ATTACHMENT 1

NORTH ANNA
UNIT 1

DISCUSSION OF PROPOSED TECHNICAL SPECIFICATION CHANGES

Figure 6.2-1 Offsite Organization for Facility Management and Technical Support

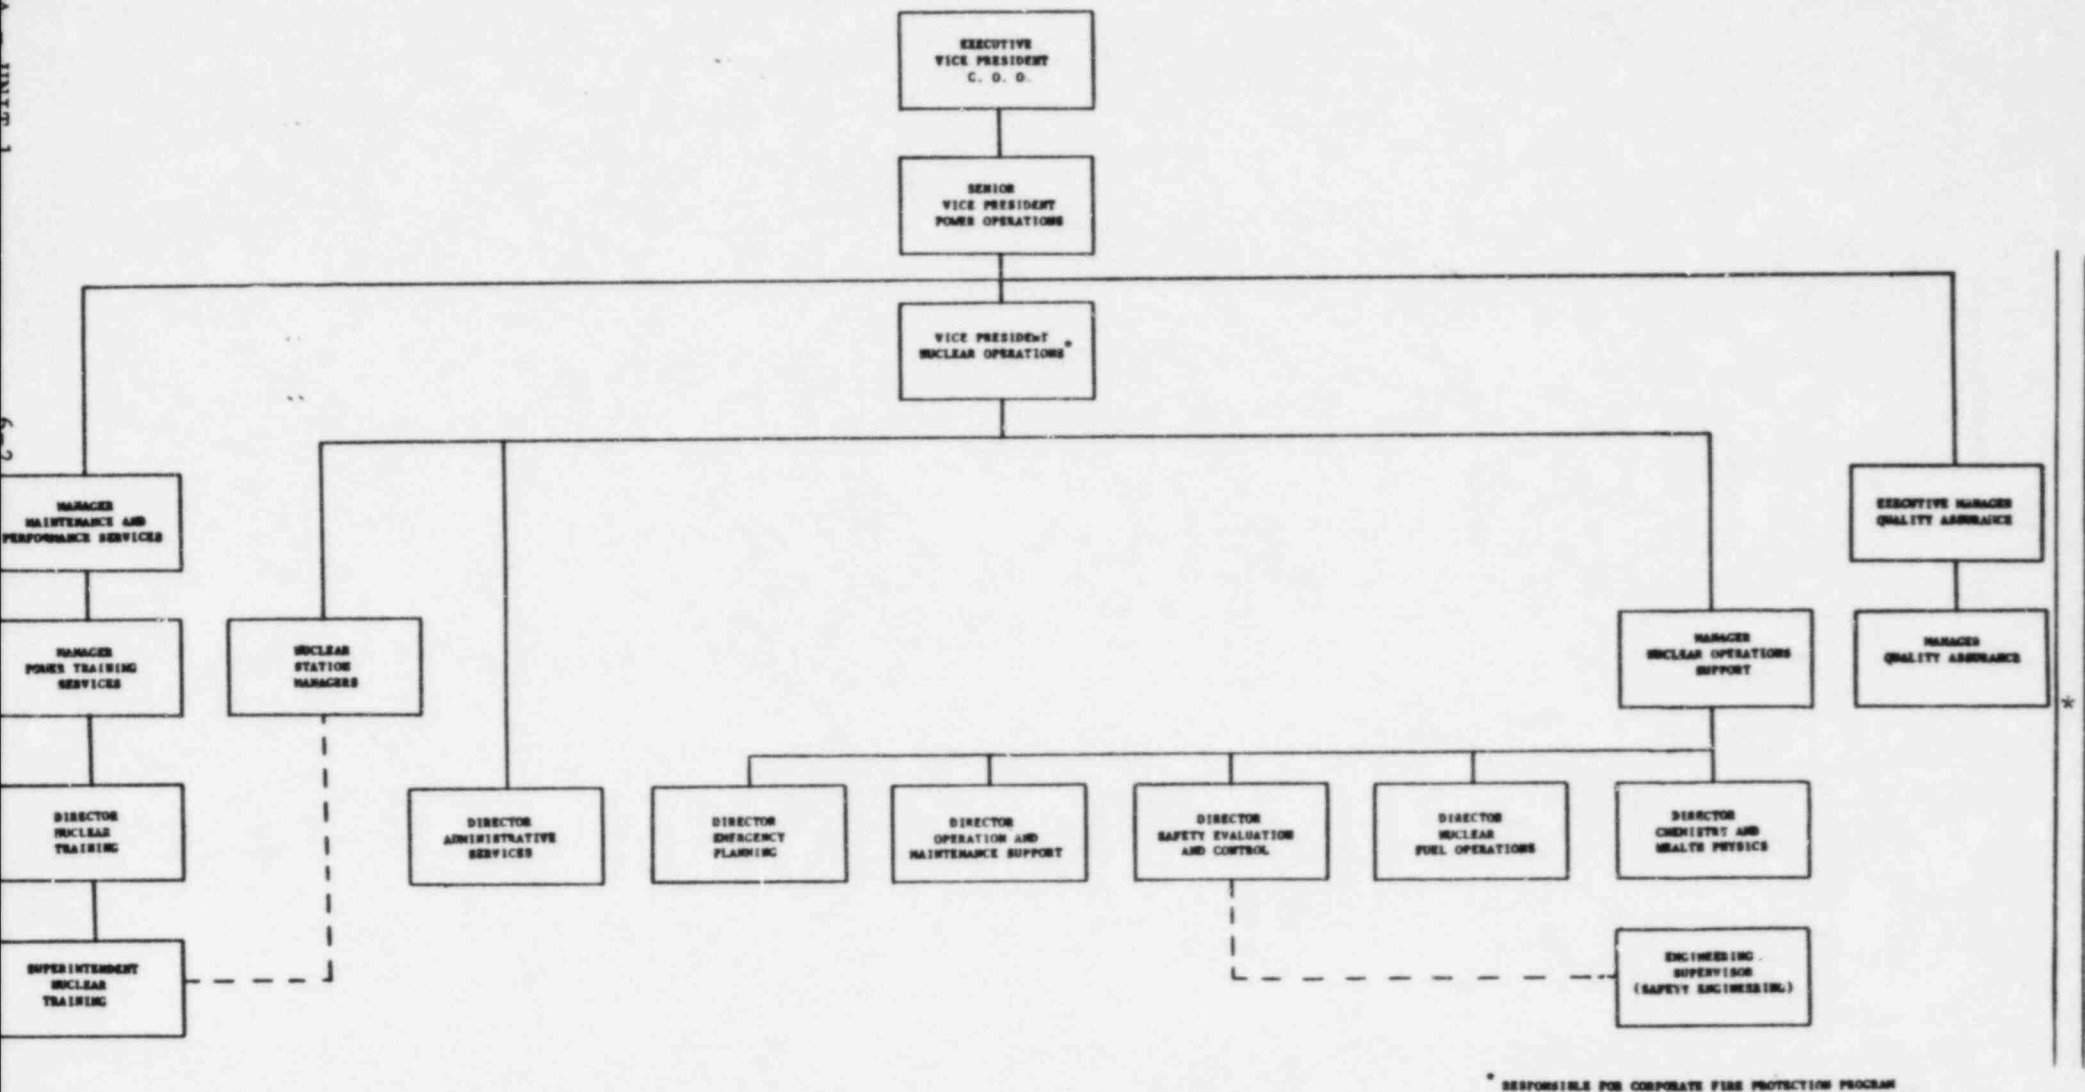
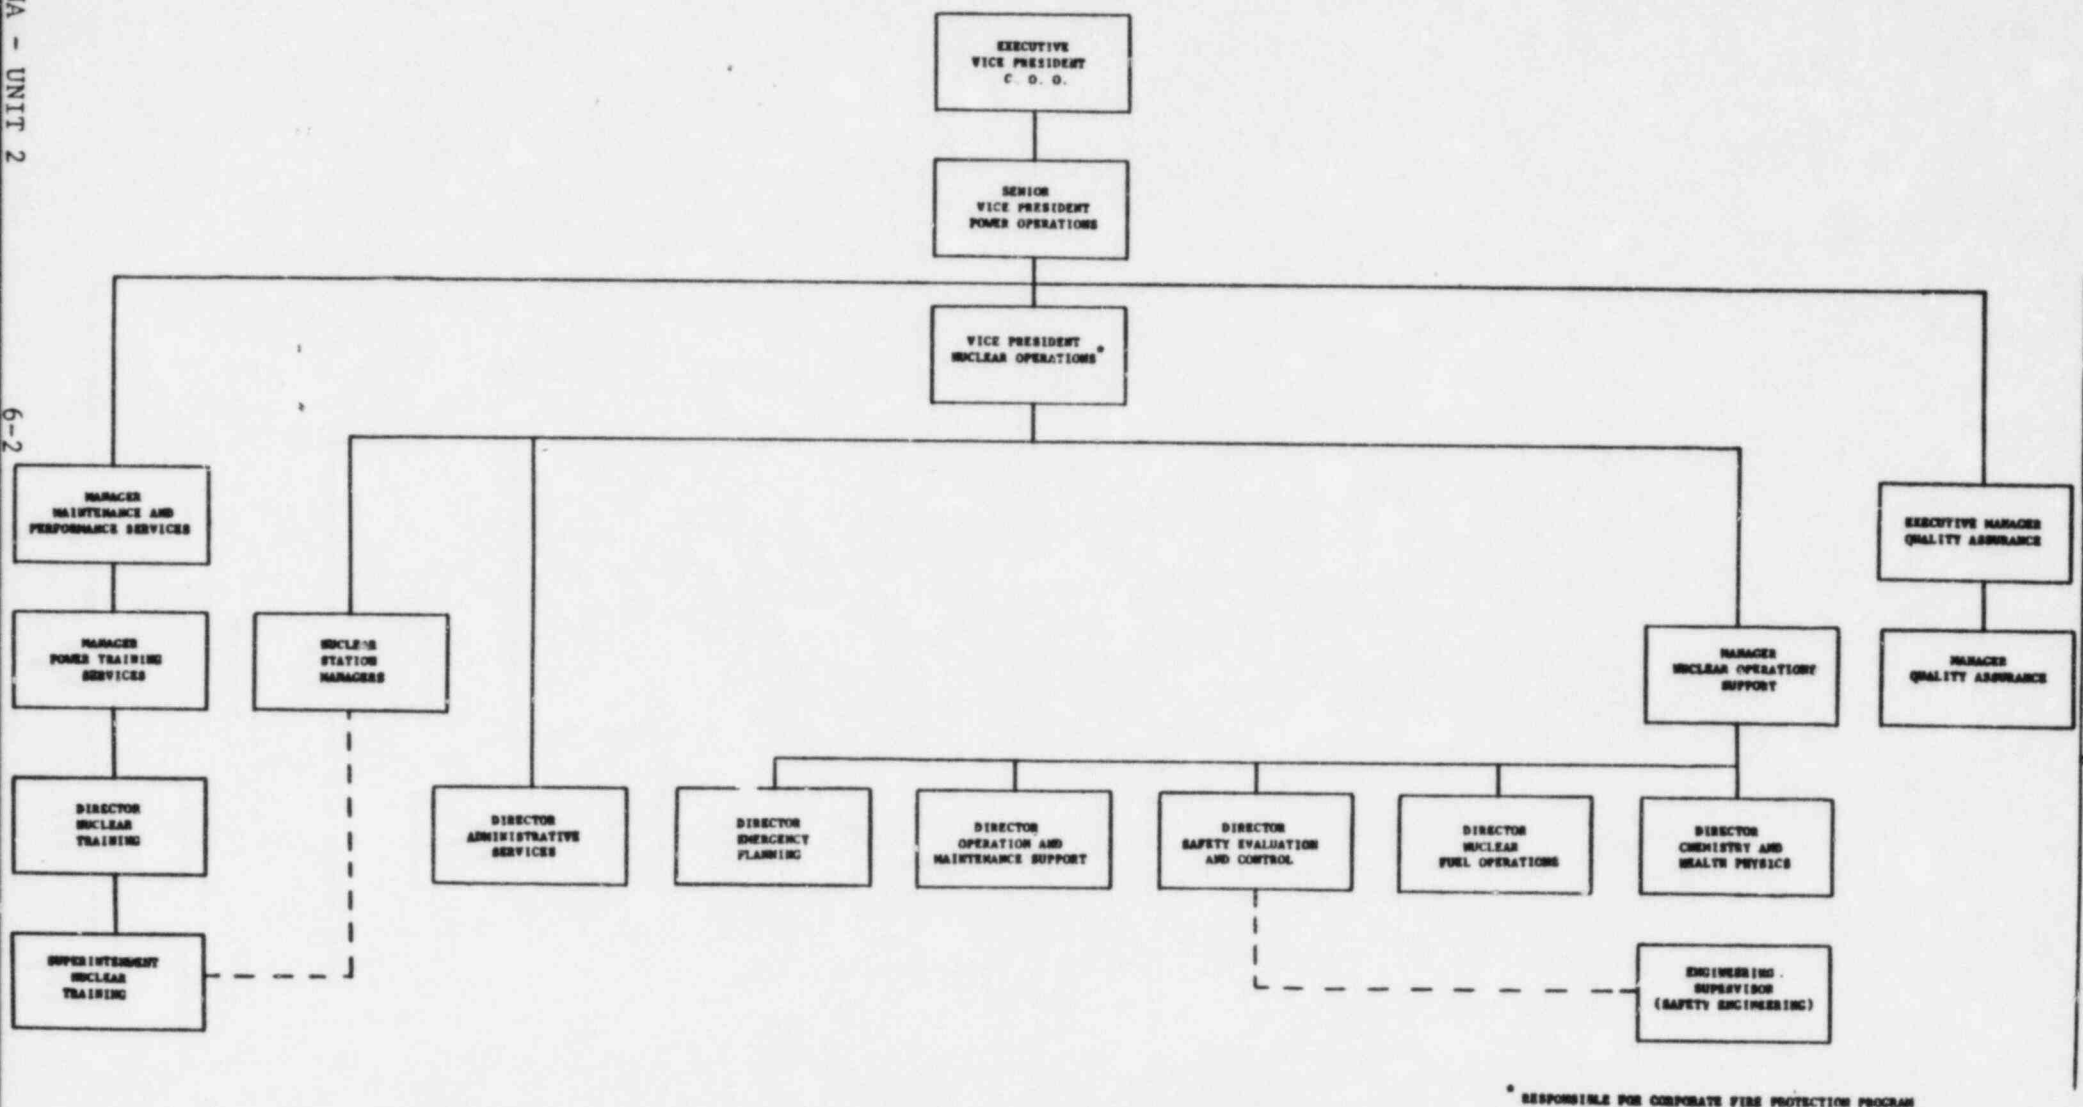
The title of the Executive Manager Environmental Services has been deleted. The Manager Water Quality will resume all the responsibilities the Executive Manager Environmental Services had for water quality. The Manager Air Quality will resume all the responsibilities the Executive Manager Environmental Services had for air quality. The Manager Water Quality and Manager Air Quality will report directly to the Senior Vice President Corporate Technical Assessment. This proposed change effects the North Anna 1 and 2 Appendix B Technical Specifications.

The reorganization within the Nuclear Operation Department and the Maintenance and Performance Services Department will aid in the quality of training activities at the power stations. The Director Training within the Nuclear Operations Department will now be the Director Nuclear Training in the Maintenance and Performance Services Department. The Director Nuclear Training will report to the Manager Power Training Services who will report to the Manager Maintenance and Performance Services who will ultimately report to the Senior Vice President Power Operations. The Director Nuclear Training will have the Superintendent Nuclear Training (who is located at the power station) reporting directly to him. The Superintendent Nuclear Training will have communications with the Station Manager.

The Director Nuclear Training will continue to plan, organize, direct and control nuclear training, so that, effective and efficient technical training is provided to Nuclear Operations. The Director Nuclear Training will assess and recommend specific training requirements for regulatory agencies as applicable and coordinate programs offerings as necessary.
